Intersection ID: 50747	Main Street: MONTELENA_DR	Cross Street: ARTESA_CT	Location:	S
ADA ID: 30604BE1DDB2	Ramp Type: PerpDiag	Initial Pass/Fail: Fail	Overall Compliance: No	Severity Score: 8.75

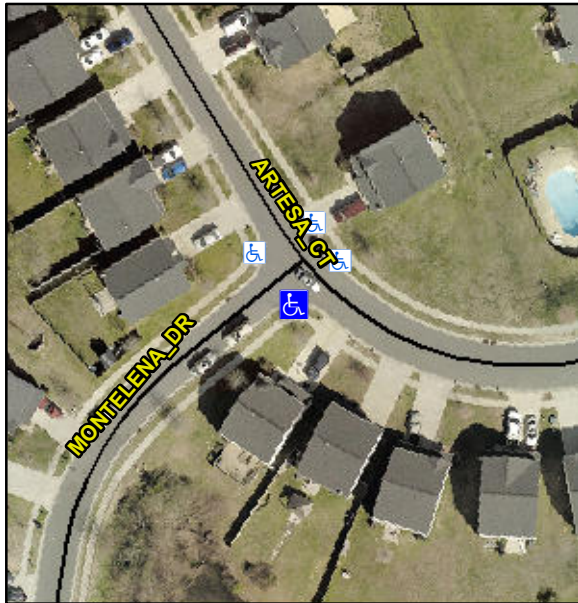
Not Found, R304.5.1

Compliance	Description	Data	Compliance	Description	Data
N/A	Ramp Length (in)	46.5	Yes	Ramp Slope (%)	7.2
No	Ramp Width (in)	46.0	Yes	Ramp XSlope (%)	1.6
N/A	Flare Type LT	N/A	N/A	Flare Type RT	N/A
N/A	Flare Slope LT (%)	N/A	N/A	Flare Slope RT (%)	N/A
N/A	Flare Traversable LT?	N/A	N/A	Flare Traversable RT?	N/A
N/A	Landing Length (in)	N/A	N/A	DWS Provided?	N/A
N/A	Landing Width (in)	N/A	N/A	DWS Contrast?	N/A
N/A	Landing Slope (%)	N/A	N/A	DWS Length (in)	N/A
N/A	Landing X Slope (%)	N/A	N/A	DWS Full Width?	N/A
N/A	Landing Curb? (Y/N)	N/A	N/A	DWS Offset (in)	N/A
N/A	Shared Landing?	N/A			
N/A	Gutter Ponding?	N/A	N/A	Gutter Slope (%)	N/A
N/A	Gutter Lip Ht (in)	N/A	N/A	Gutter X Slope (%)	N/A
N/A	Painted X Walk1?	No	N/A	Painted X Walk2?	No
	X Walk 1 Direction	To NE		X Walk 2 Direction	To NW
N/A	X Walk 1 Width (in)	N/A	N/A	X Walk 2 Width (in)	N/A
	X Walk 1 Slope (%)	2.8		X Walk 2 Slope (%)	4.6
	X Walk 1 X Slope (%)	3.1		X Walk 2 X Slope (%)	1.2

Remove & Replace Curb Ramp With Two New Directional Ramps or Equivalent.
